Our Ref: S187F/020b
Date: 26 September 2014

RE: ANGUS PLACE AND SPRINGVALE MINE EXTENSION PROJECTS - RESPONSE TO IESC ADVICE

Figure 1: Subsidence Profile of Extracted LW1 and LW401-LW412 at Springvale Mine

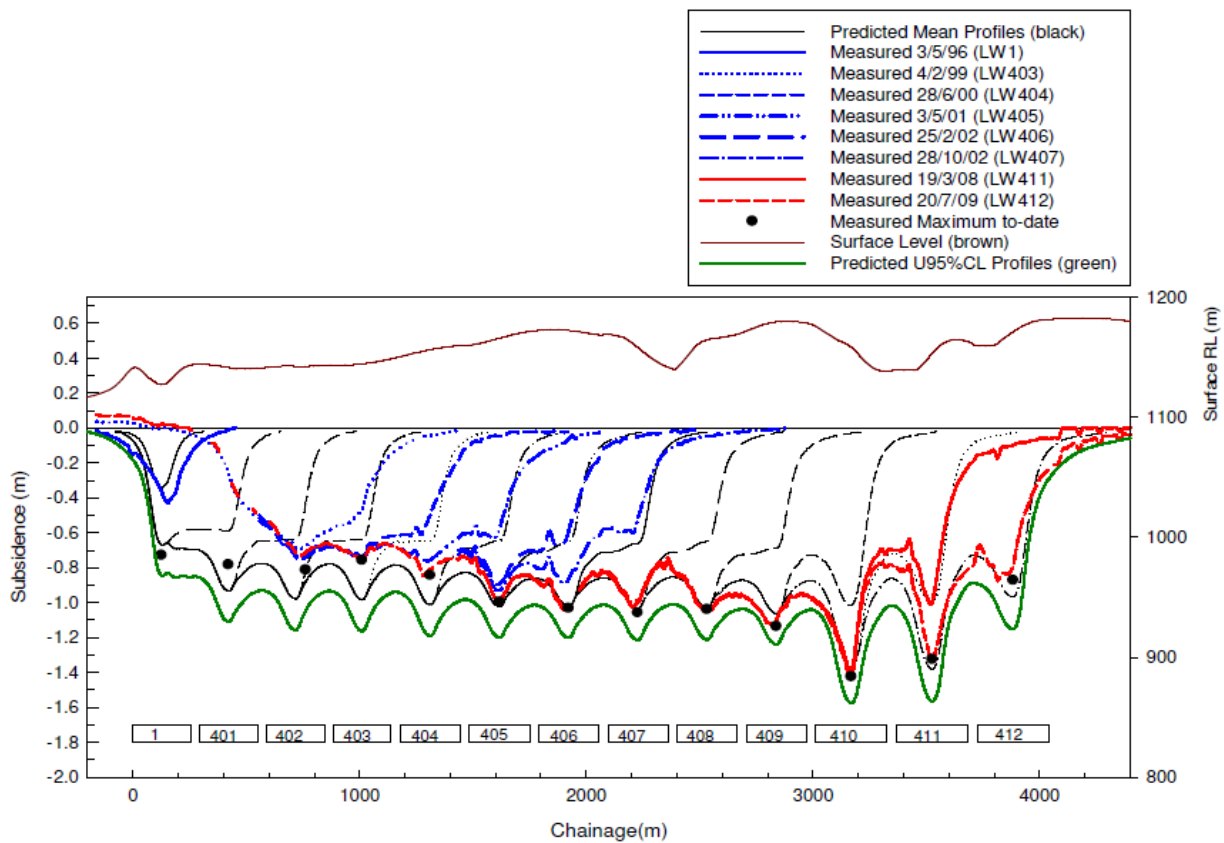
Q4. Which, if any, of these strategies does the IESC recommend, and why?

As stated above, mining experience at Angus Place and Springvale does not concur with IESC's assertion of a significant delay between mining and observed subsidence. Figure 1 shows a subsidence profile for the extracted LW1, LW401 – LW412 at Springvale Mine. It is noted extraction of LW413 had not commenced and cumulative impacts from its extraction is not shown in the subsidence. As noted in Table 3.4 of the Springvale EIS the void widths of LW1, LW401 – LW409 ranged between 254 and 266m while the void width of LW410 – LW412 was 315m. The subsidence data show that the development of subsidence is predictable, with approximately 70% of measured subsidence occurring within one month of undermining, 95% is completed within 18 months of extraction and 100% within 3 years. Of note is that the measured maximum subsidence is consistent with the predicted mean profile.
